<b>SERVICE LETTER NUMBER 138</b>			
<b>TITLE: 10000 and 13000 Nose Gear End Cap Cracks</b>			
BY: J. Sortor	AIRCRAFT MAKE/MODEL(S):	FLOAT MODEL(S):	NOTE(S):
APP: K. Taylor	FIREBOSS 802/802A	10000A	<b>MANDATORY COMPLIANCE</b> <b>S.L. P/N 1003610</b> <b>ECO--23055</b>
DATE: 11-DEC-12	VIKING DHC-6	13000A	
REV: B

**FAA APPROVAL HAS BEEN OBTAINED FOR TECHNICAL DATA IN THIS PUBLICATION THAT AFFECTS STC OR TSO DESIGN COMPLIANCE**

FIGURE 1

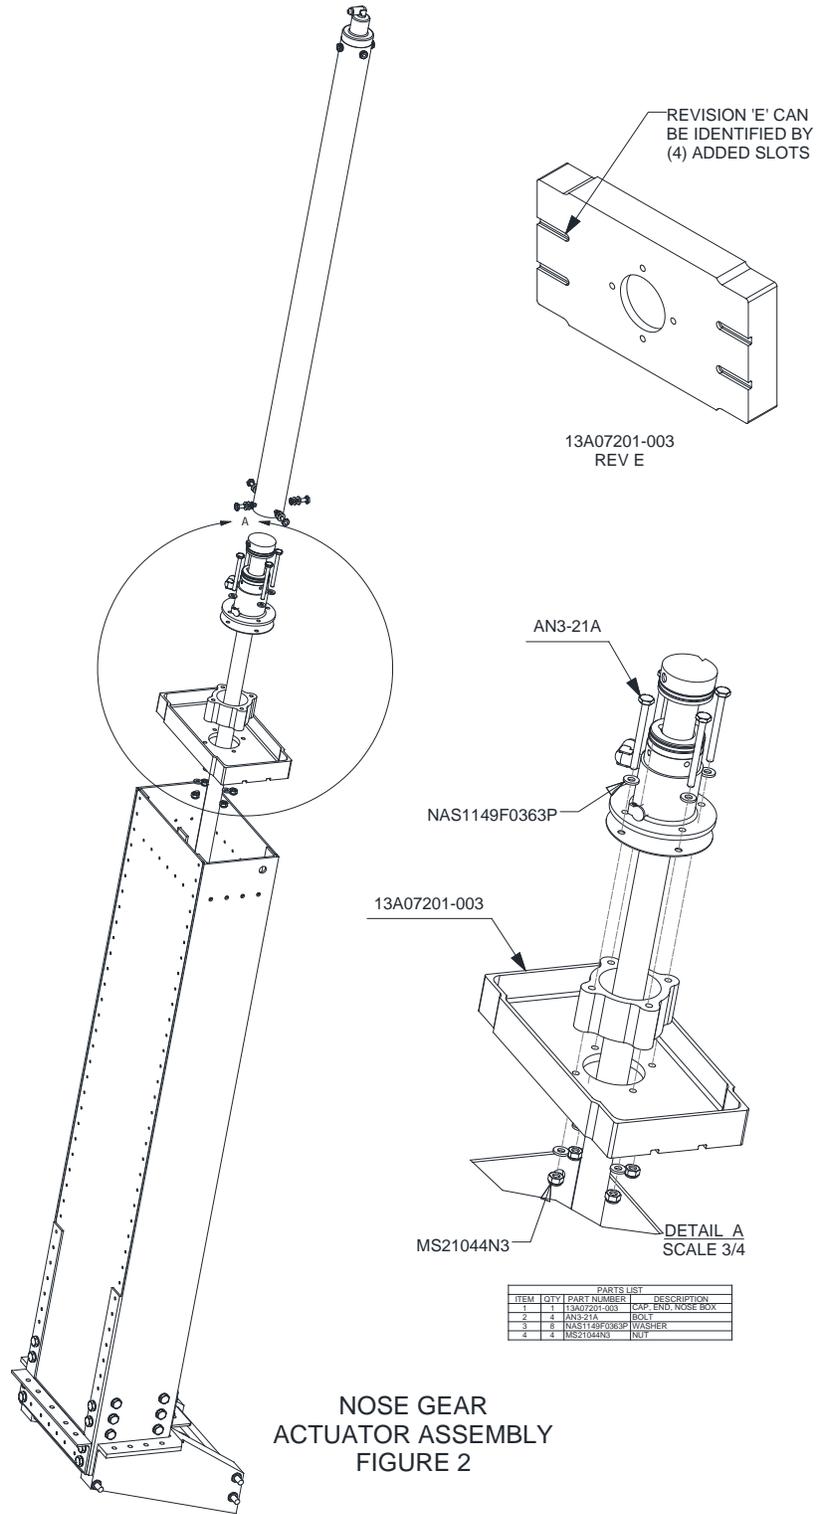
Several Nose Gear Box End Caps, part #13A07201-003 have been found to have cracks propagating from around the Cylinder Mounting Flange bolts (4). If these cracks go undetected there is a possibility that the End Cap, Part #13A07201-003 can break and let the actuator cylinder move to a selected gear position without actuating the gear properly. This condition could potentially lead to a gear indication suggesting that a selected nose gear position has been reached, when it has not.

A close visual inspection must be accomplished within the next 25 hours of operation, and every 50 hours thereafter. The cracks will be best visible by looking at the forward face of the End Cap, Part #13A07201-003 through the forward open end of the Nose Gear Box. It appears that the cracks start just above the top mounting bolt and just below the bottom mounting bolt as shown in Figure 1. If cracks are found, the End Cap Part #13A07201-003 must be replaced with the new revision, End Cap, Part #13A07201-003, Revision E, dated October 2nd, 2012 or later. In addition, replace the (4) AN3-20A mounting bolts with (4) AN3-21A bolts. After inspection and/or replacement, re-adjust the gear "down" over-center lock so that it hits the end of the lock-up track and has little to no preload pressure, since the preload pressure would cause extra stress at the Cylinder Mounting Flange and the End Cap.

NOTES: Figure 1 shows the part that is cracked, and figure 2 shows its location on the nose box assembly. This is the forward side of the part which can be seen looking into the open (front) end of the nose gear box. No disassembly should be required to examine this area. The area should be thoroughly cleaned before inspecting. Use good lighting. If in doubt, dye penetrant inspection can also be accomplished.

Replacement of the older revision parts with revision E parts will eliminate the requirement for 50 hour interval inspections, but this inspection should still be accomplished at 100 hour intervals thereafter. Revision E parts can be identified by (4) added slots as shown in Figure 2.

If evidence of cracking is found in Nose Box End Cap either by visual or dye penetrant inspection per figure 1, the following instructions will be accomplished to replace damaged Nose Box End Cap:
